APPLICATION NO.	FILING DATE	FIRST NAMED INVENTOR	ATTORNEY DOCKET NO.	CONFIRMATION NO.
10/089,015	03/25/2002	Hideki Fujiwara.	F-7369	9145

Office Action Summary

DETAILED ACTION

FIG. 7

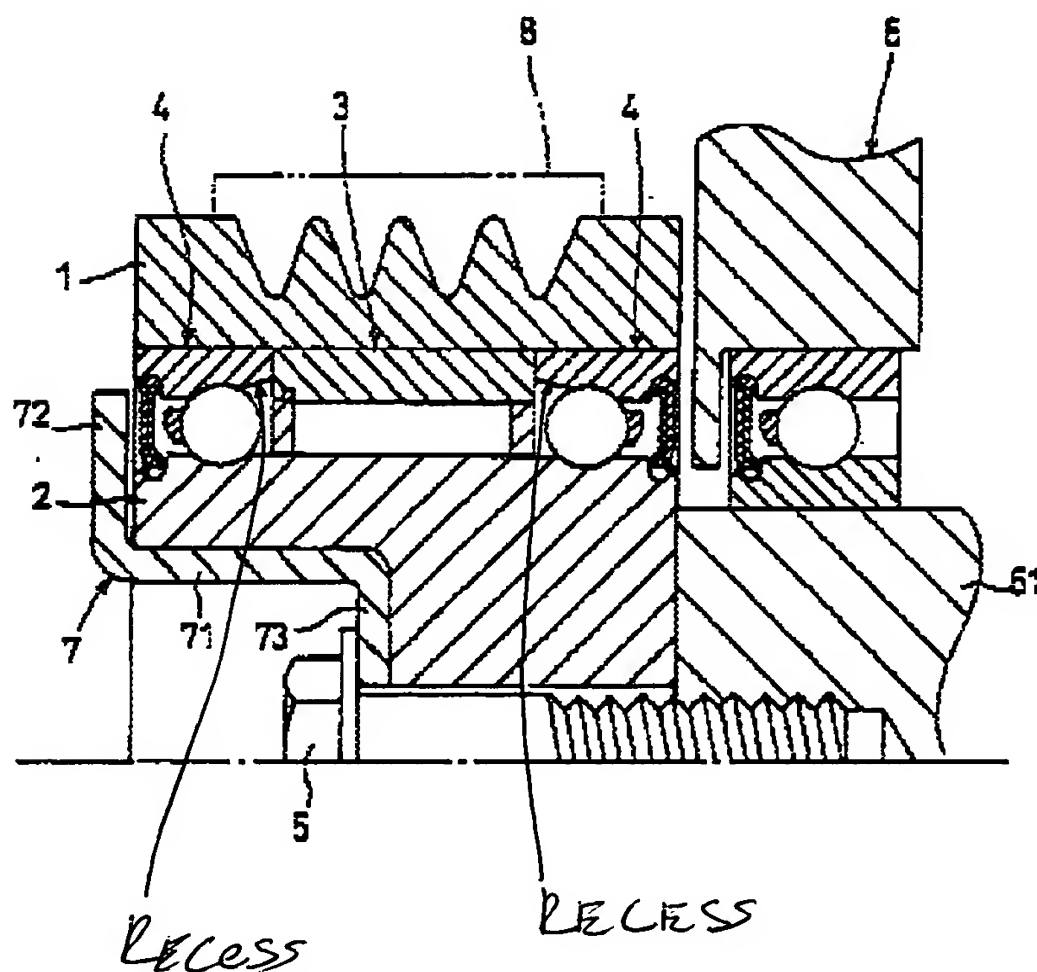
In addition, Wagner et al. does not disclose a recess between the clutch and the roller. GB (2,330,884) disclose a pulley unit having a clutch (34) and a roller (43) in an annular space between a pulley body (1) and a shaft (20) and a recess (see attached drawing) in the inner surface of the outer raceway between the clutch and the roller in order to obtain easy access of the bearing. Therefore it would have been obvious to one of ordinary skill in the art at the time of the invention to further modify the inner surface of the pulley body of Wagner et al. so that it includes a recess between the clutch and the roller in view of GB (2,330,884) in order to obtain easy access of the bearing into the raceways.

Regarding the remarks relating to claim 8 to GB (2,330,884). GB (2,330,884) clearly shows the recess as indicated in the attached drawing below.
